Re: Section 16 Planning Application for Proposed Temporary Cold Storage for Poultry and Distribution Centre for a Period of 3 Years and Filling of Land for Site Formation Works at Lots 471 S.B RP (Part), 472, 473, 474, 475, 476, 483, 501, 502, 504 S.B, 505 and 506 S.B RP in D.D. 89 and Adjoining Government Land, Man Kam To Road, Sha Ling, New Territories

We submit herewith Further Information (FI) with 4 copies of Responses-to-Comments Table with Appendices for the consideration by relevant Government departments or Town Planning Board.

Table 1	Response-to-Comments
Appendix 1	Revised Planning Statement
Appendix 2	Revised Environmental Assessment
Appendix 3	Revised Drainage Impact Assessment
Appendix 4	Figure RC-01

Figure 3.3: On-site Road Segments and Loading/ Unloading Areas

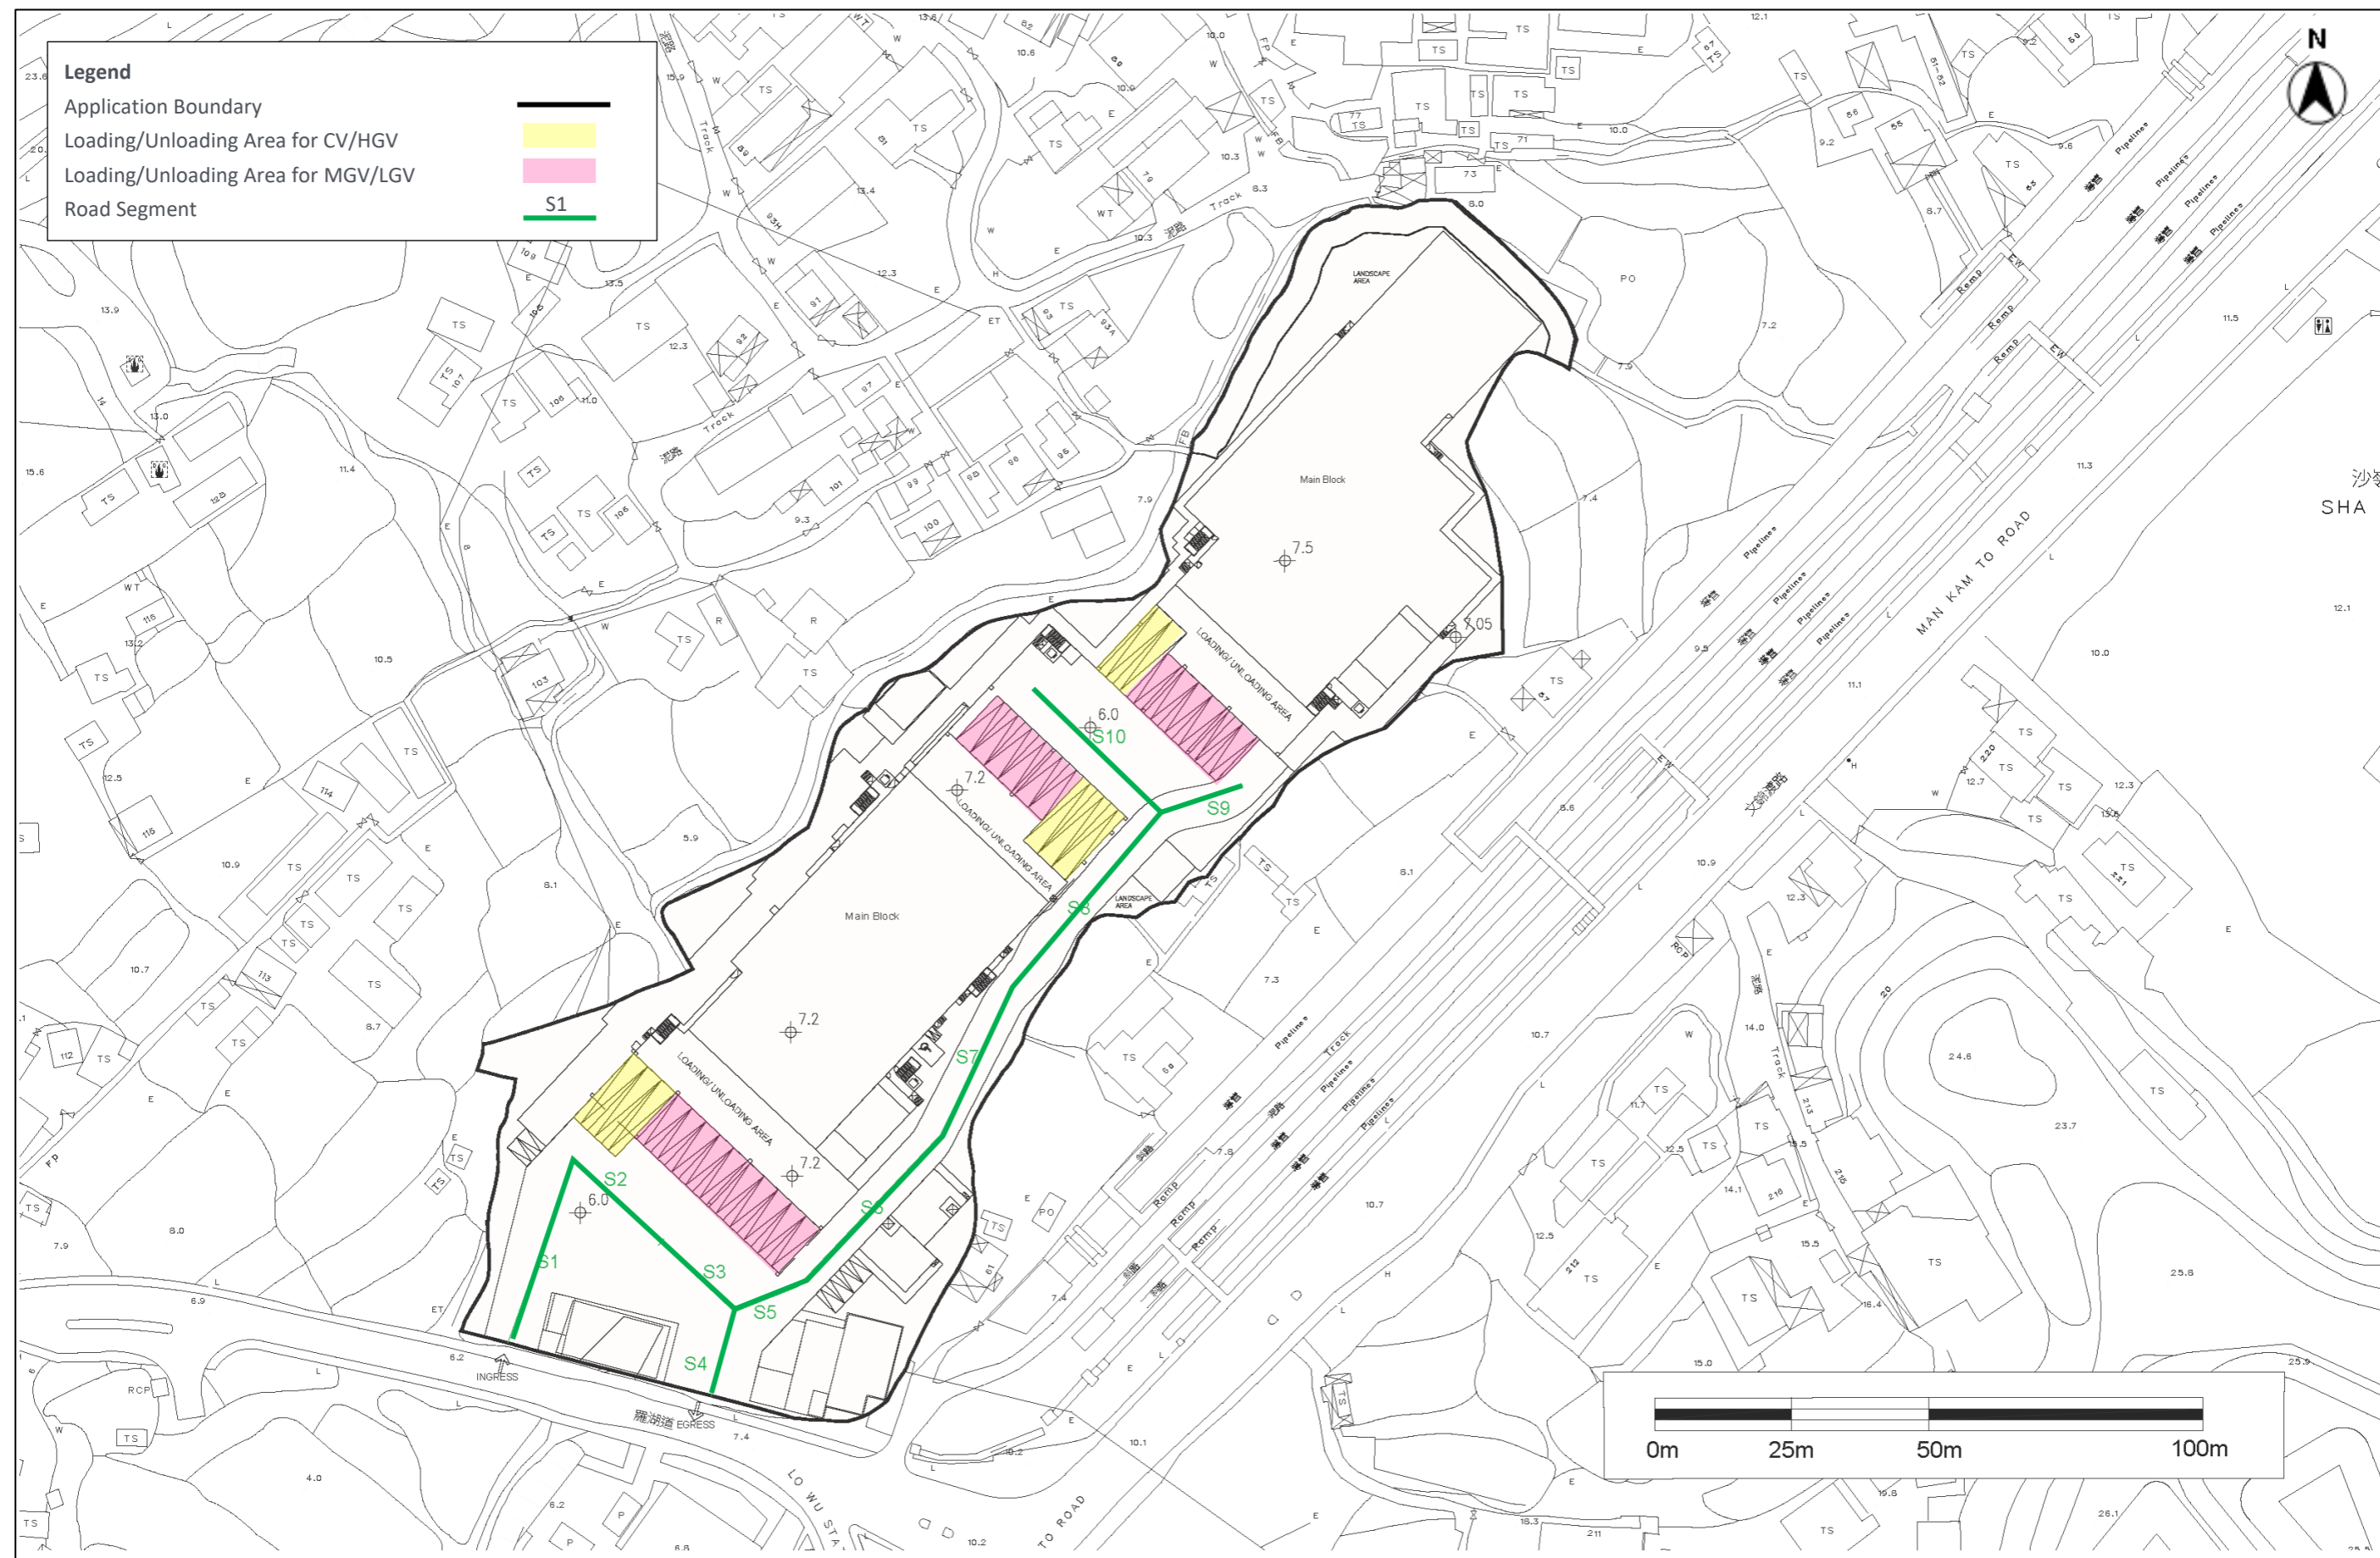
Date	Department	Comments	Responses
		pose less noise nuisance.	nuisance to the nearby NSRs.
		<p>2. Section 3.3.30 and Figure 3.3 –</p> <p>i. Section 3.3.30 mentioned that the loading and unloading area of container vehicle/HGV/MGV will be set up near the site entrance to minimise on-site movement. However, Figure 3.1 shows that there are five loading and unloading area for container vehicles in the middle of the site far away from site entrance . Please review and clarify.</p>	Paragraph 3.3.30 of the EA Report has been revised to “The loading and unloading area of container vehicle/ HGV/ MGV near the Site entrance/exit area will be used first especially during evening-time and night-time period to minimise the on-site movement these vehicles as soon as practicable as shown on <i>Figure 3.4.</i> ” (Appendix 2 refers).
		<p>ii. To minimise noise nuisance from on-site vehicles manoeuvring, especially during evening-time and night-time periods, the vehicles should use the loading and unloading area near the site entrance during evening-time and night-time periods as far as practicable. In case there are constraints to do so, please spell out such constraints in the report.</p>	Paragraph 3.3.30 has been amended to supplement that “4. <i>The loading and unloading area of container vehicle/ HGV/ MGV near the Site entrance/exit area will be used first especially during evening-time and night-time period to minimise the on-site movement of these vehicles as far as practicable as shown on Figure 3.4. Except there is overloading at the loading and unloading area which is the closest to the site entrance.</i> ” (Appendix 2 refers).

Figure 3.4: Mitigation Measures for on-site Vehicle Movement

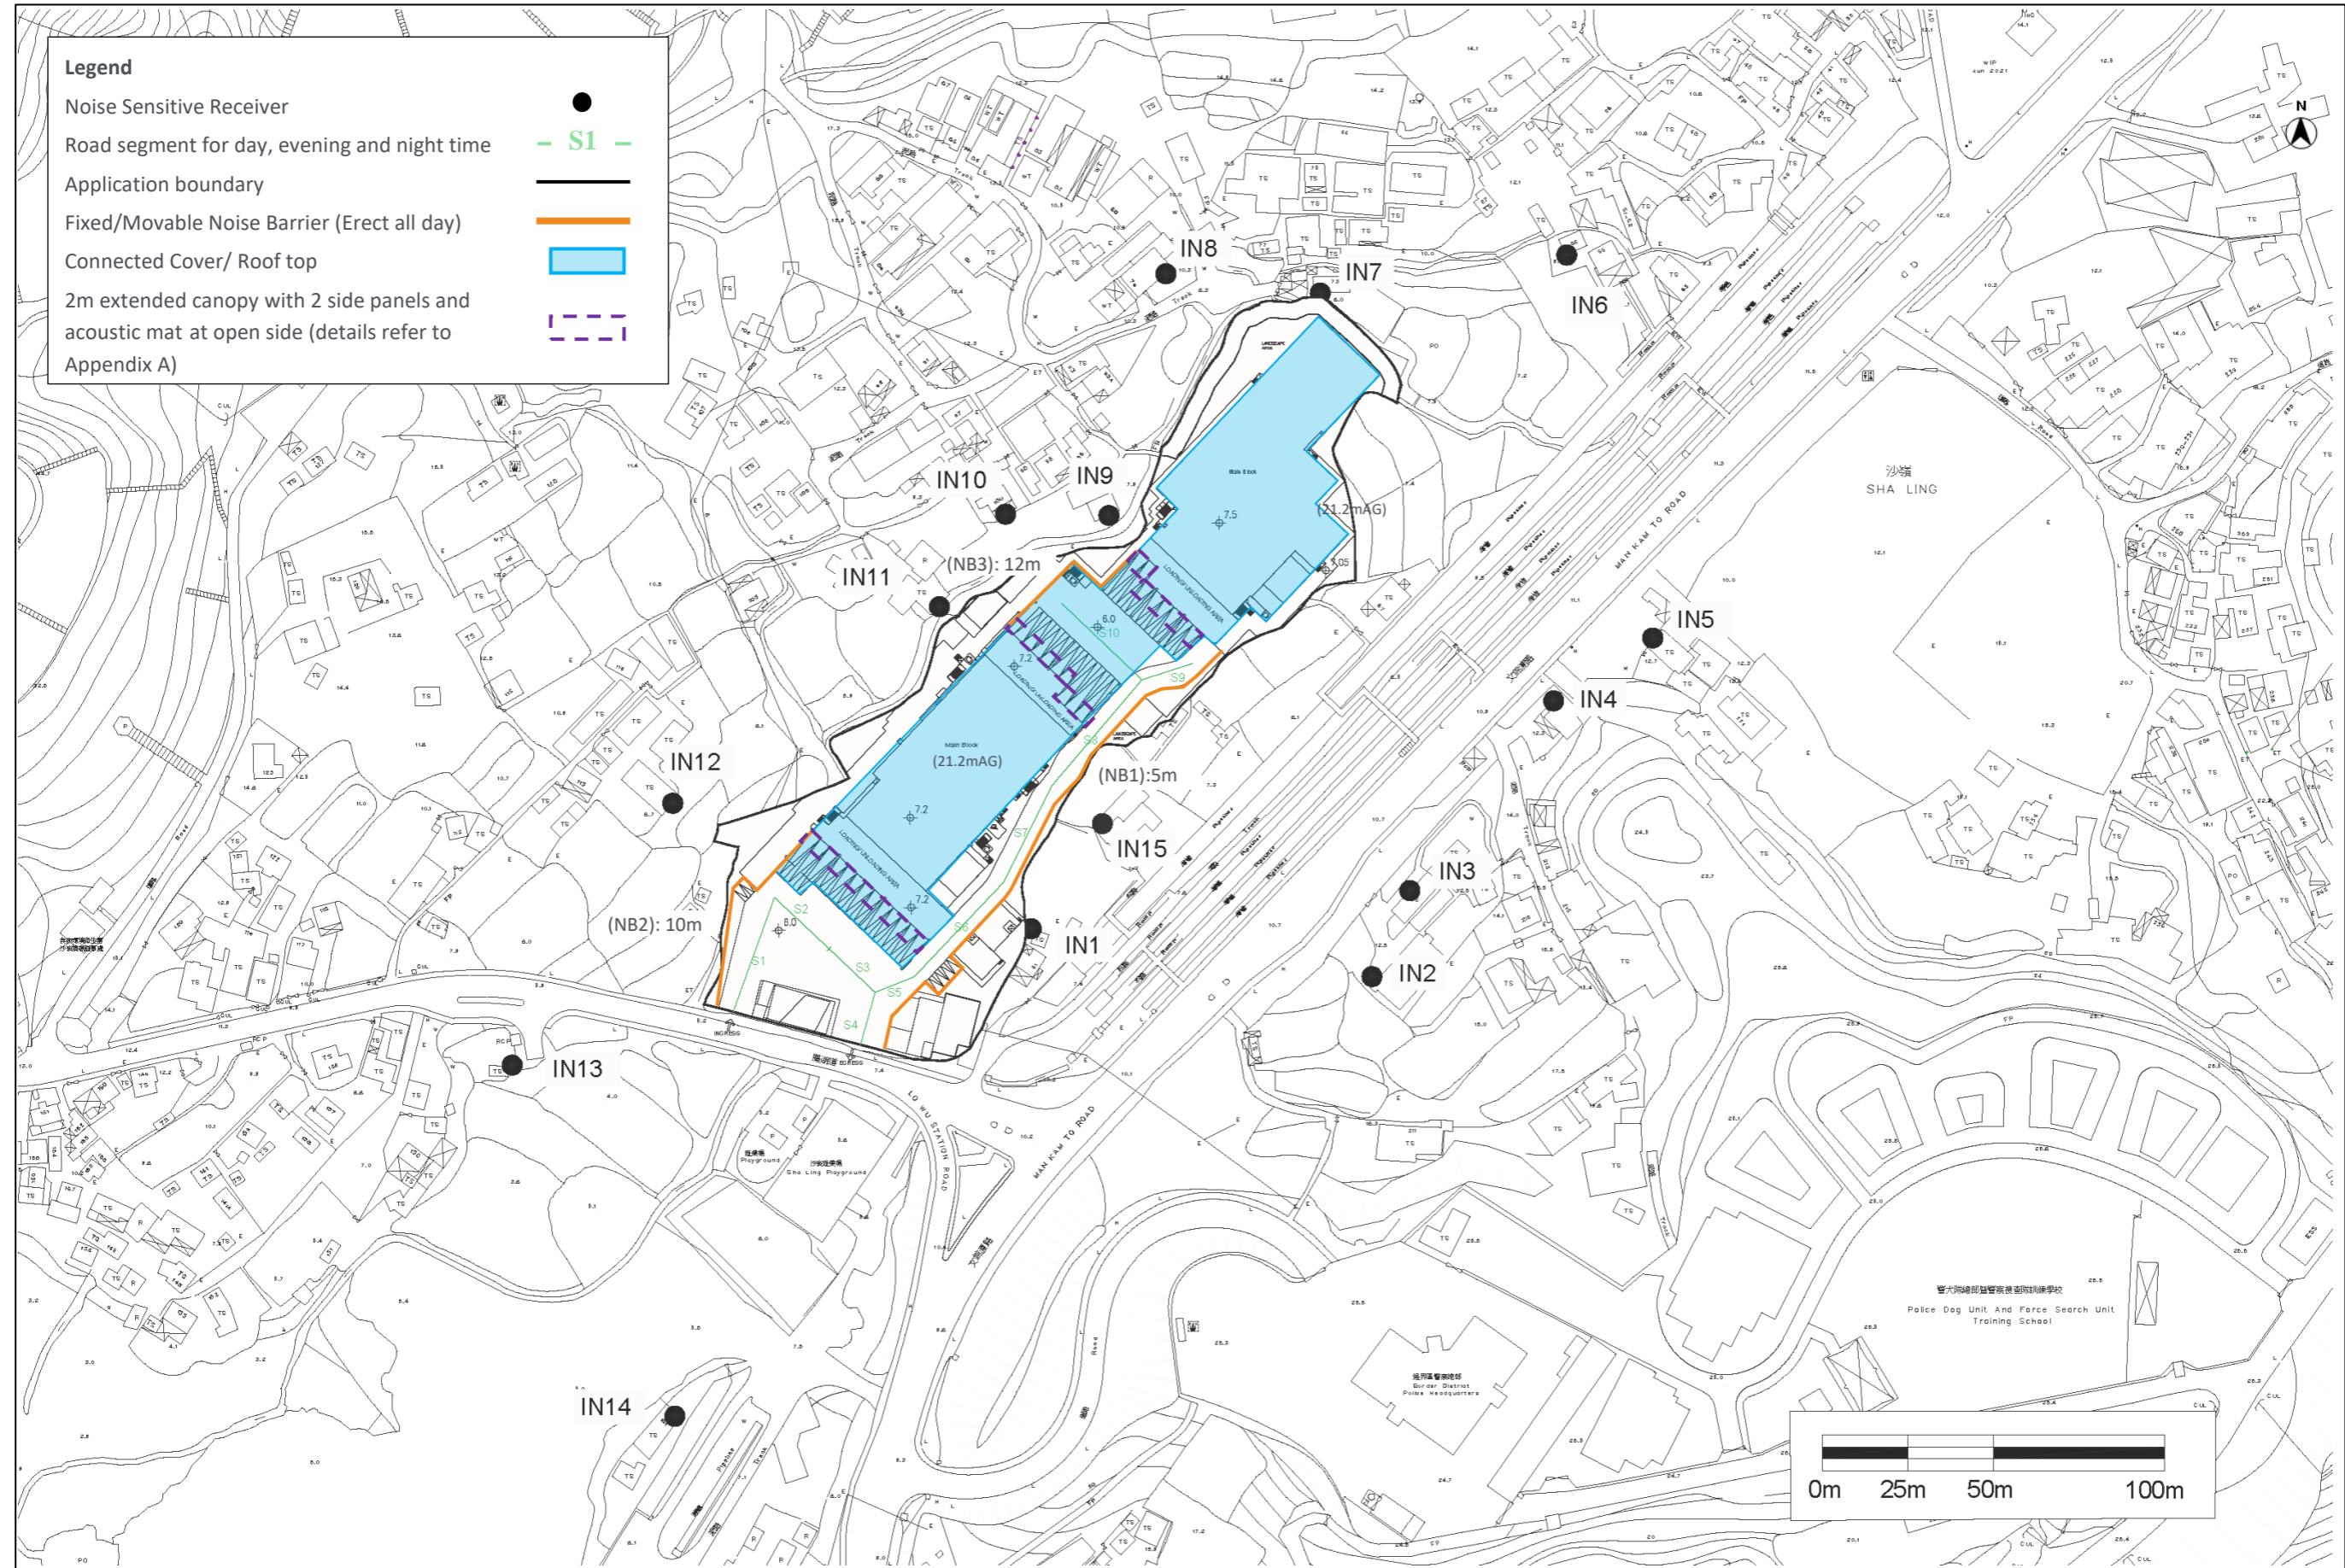
ii. For clarity, please consider to indicate in Figure 3.4 that the loading/unloading areas will be provided with mitigation measures, i.e. canopy and side panels on both sides, and acoustic mat at open side of loading/unloading platform.	Figure 3.4 of the EA Report has been updated to indicate the 2m extended canopy with 2-side panels and acoustic mat at open side of loading/ unloading areas (Appendix 2 refers).

12. Figure 3.4 - There appears to be a gap between NB1 and structure of Block 2. To prevent noise leakage through the gap,	Figure 3.4 of the EA Report has been revised that there is no gapping between NB1 and structure of Block 2 (Appendix 2 refers).

Figure 3-1: Identification of Surrounding Catchments

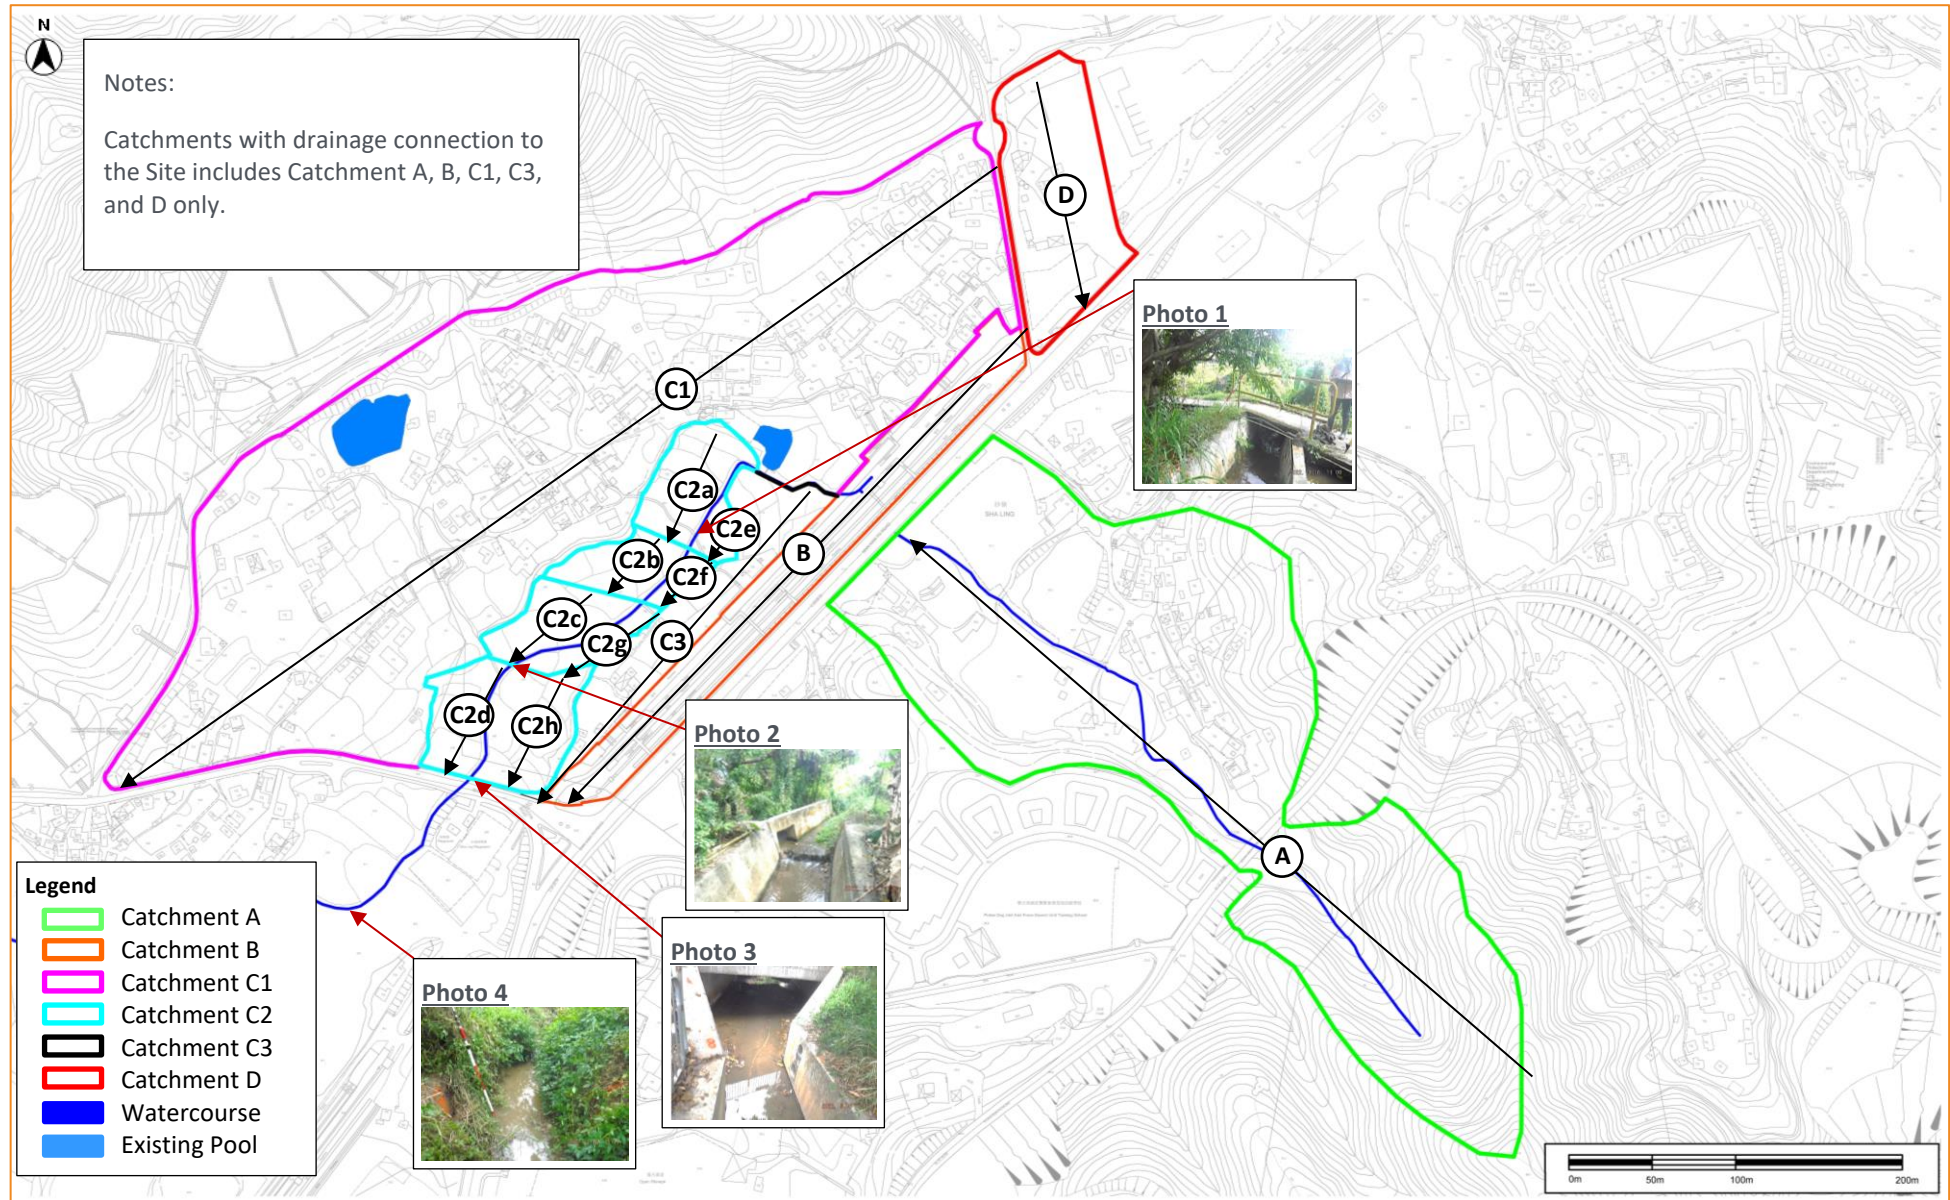
<p>3. Para. 3.2.8 refers. The photos of relevant watercourse are missing in the Figure 3-1 and the submission.</p>	<p>The photos of relevant watercourse are added in the Figure 3-1 (Appendix 3 refers).</p>
		<p>4. Para. 3.6.12 refers. It is mentioned that “part of the flow will adopt another arrangement at the catch pits CP7 and MH15 where partial stormwater will bypass the proposed Uchannel and overflow into the proposed underground stormwater storage tank”. Please elaborate on the mechanism of separating the partial stormwater and the proposed underground stormwater storage tank. Please also specify under what condition that the concerned mechanism will be triggered.</p>	<p>Para 3.6.12 has been revised (Appendix 3 refers).</p>
		<p>5. Para. 3.6.14 refers.</p> <p>i. Please provide the decking over details and proposed</p>	<p>i) The existing watercourse (about 1.5 m (W) x 0.9 m (D)) running in a northeast to southwest direction of the Site will be maintained and</p>
